No. 67-19

Rev. I

SUBJECT: A NEW THROTTLE CONTROL FOR THE BEECHCRAFT MUSKETEER

AIRCRAFT AFFECTED: All BEECHCRAFT Model 23, A23 and A23A aircraft, serials prior to M-1069; all Model A23-19, serials prior to MB-265; all Model A23-24, serials prior to MA-273.

FIGURE I

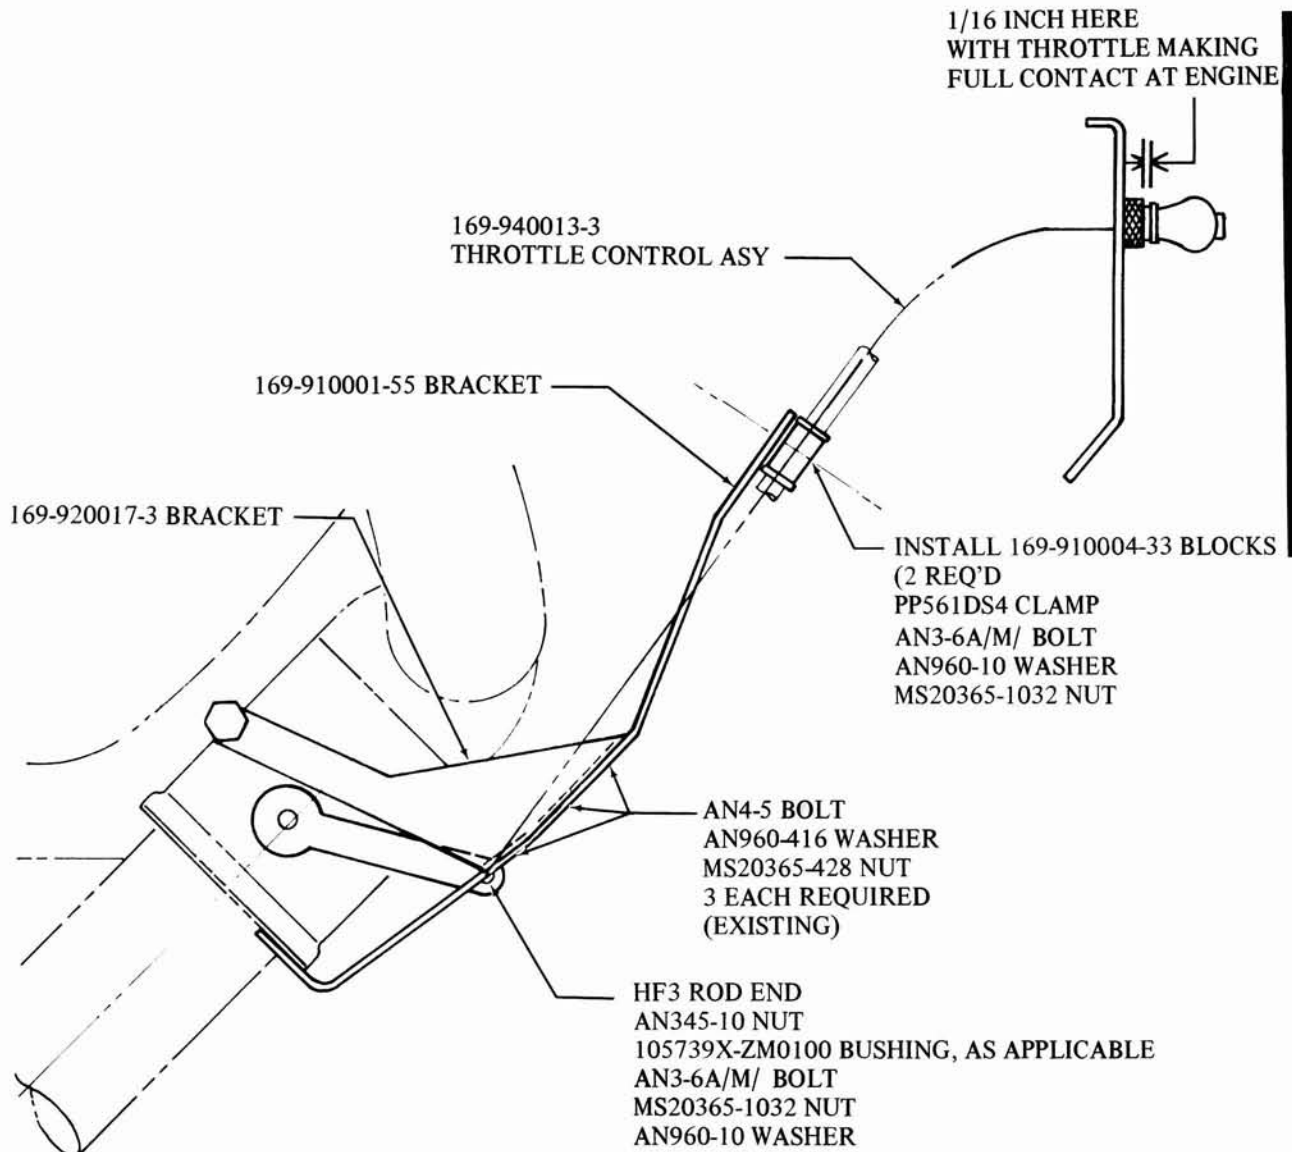
8. Tie or clamp the control as required to prevent abrasion with other components. Adjust the control cable so that when the control is making full throttle contact at the throttle body, a gap of 1/16 inch remains between the knurled nut and the stop nut at the instrument panel. (See

figure 1 for an illustration of the properly rigged throttle control assembly installed in Part I.)

12. Tie or clamp the control as required to prevent abrasion with other components. Adjust the control cable so that, when the control is making full throttle contact at the throttle body, a gap of 1/16 inch remains between the knurled nut and the stop nut at the instrument panel. (See figure 1 for an illustration of the properly rigged throttle control assembly installed in Part II.)

FIGURE 2

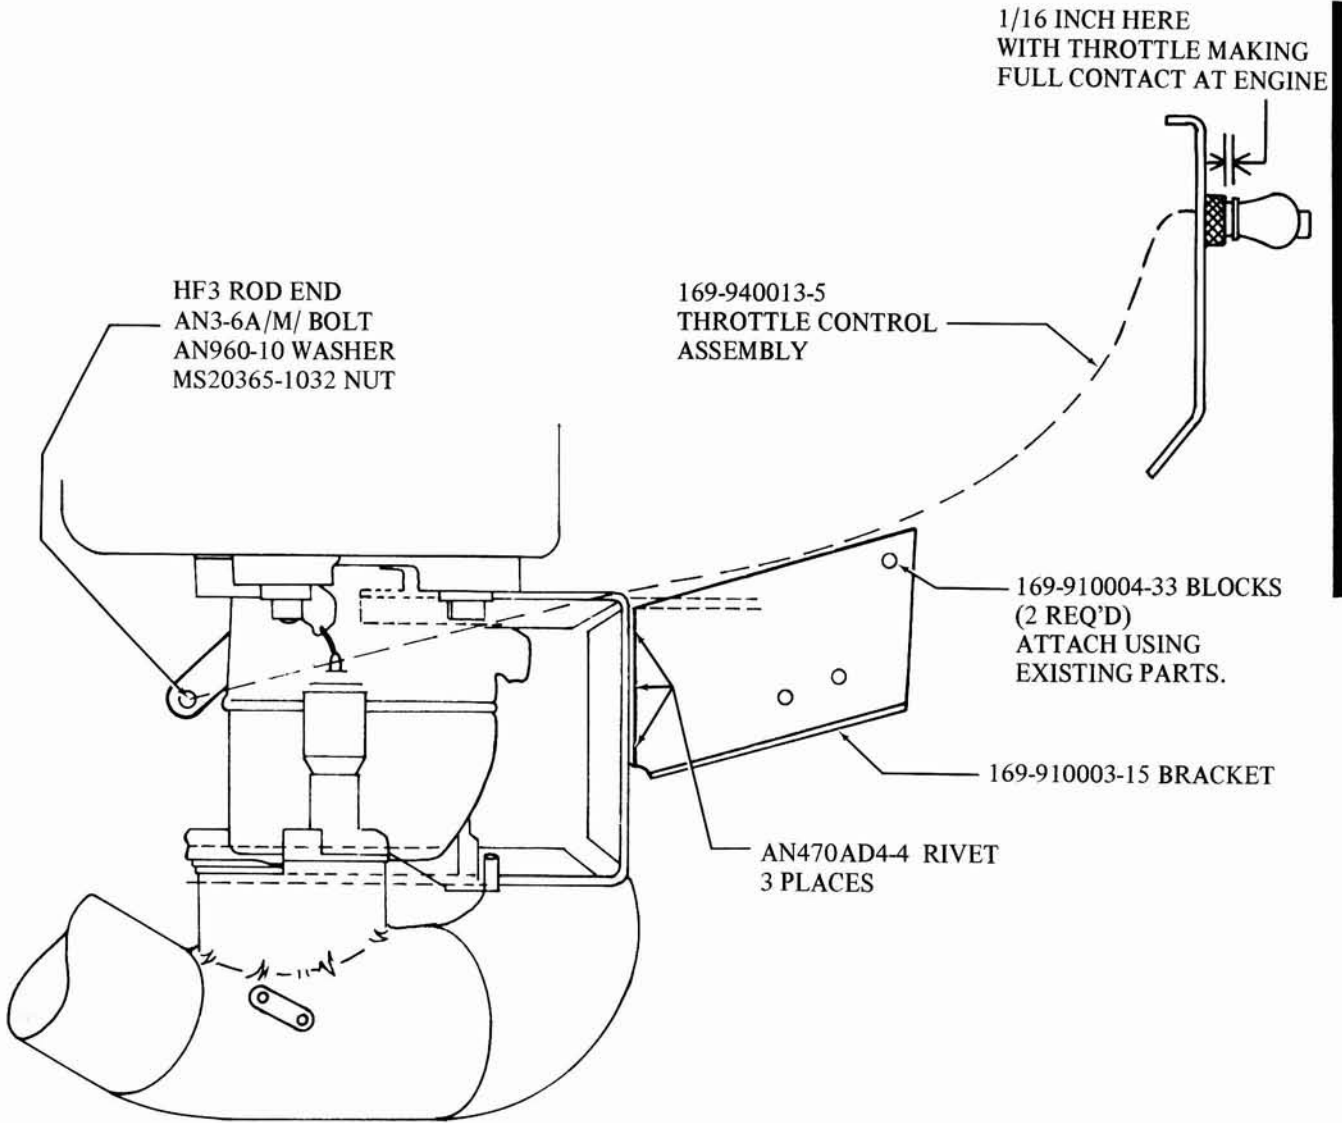
7. Adjust the control cable so that, when the control is making full throttle contact at the throttle body, a gap of 1/16 inch remains between the knurled nut and the stop nut at the instrument panel. (See figure 2 for an illustration of the properly rigged throttle control assembly installed in Part III.)

FIGURE 3

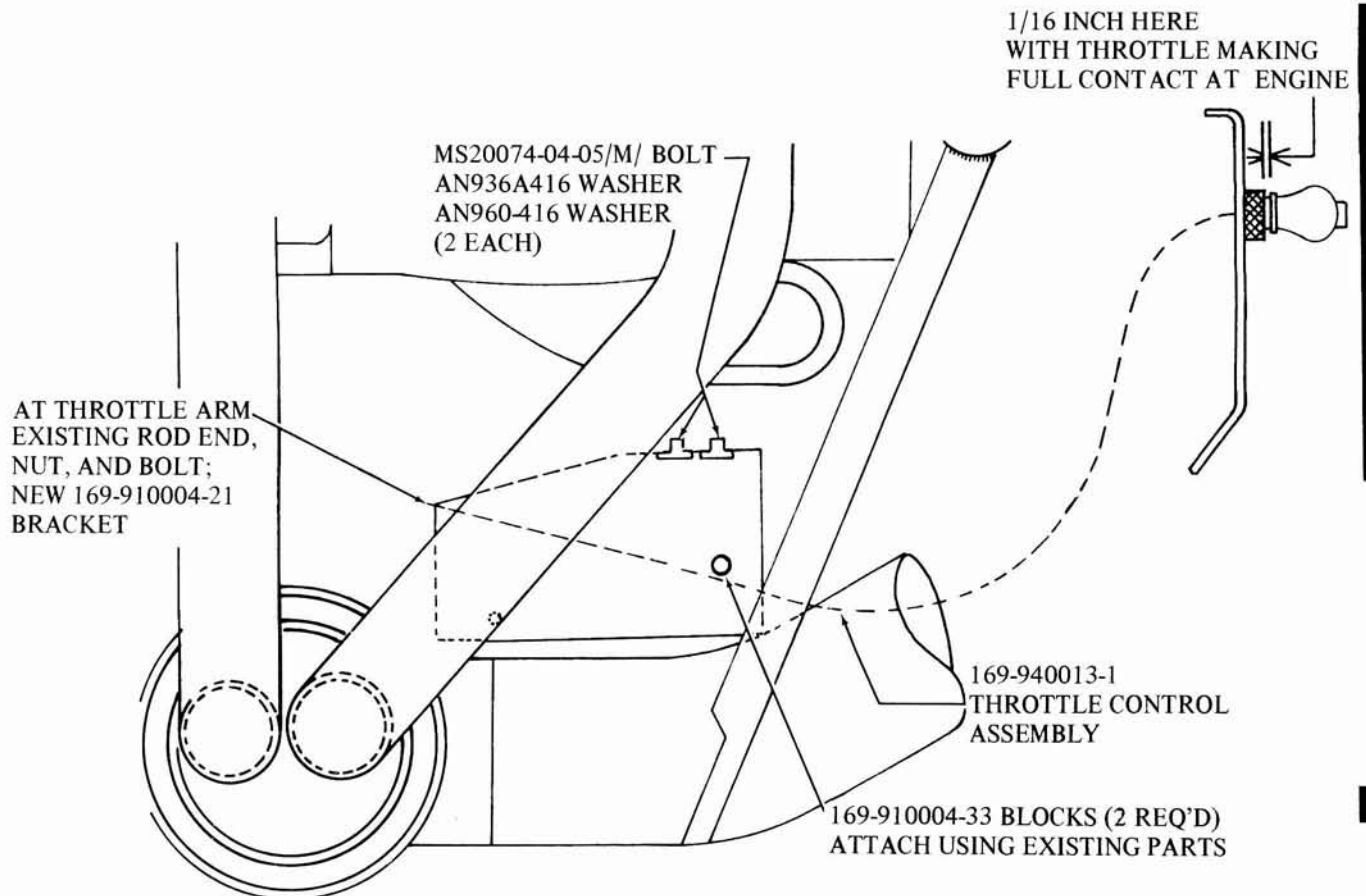
6. Adjust the control cable so that, when the control is making full throttle contact at the throttle body, a gap of 1/16 inch remains between the knurled nut and the stop nut at the instrument panel. (See figure 3 for an illustration of the properly rigged throttle control assembly installed in Part IV.)
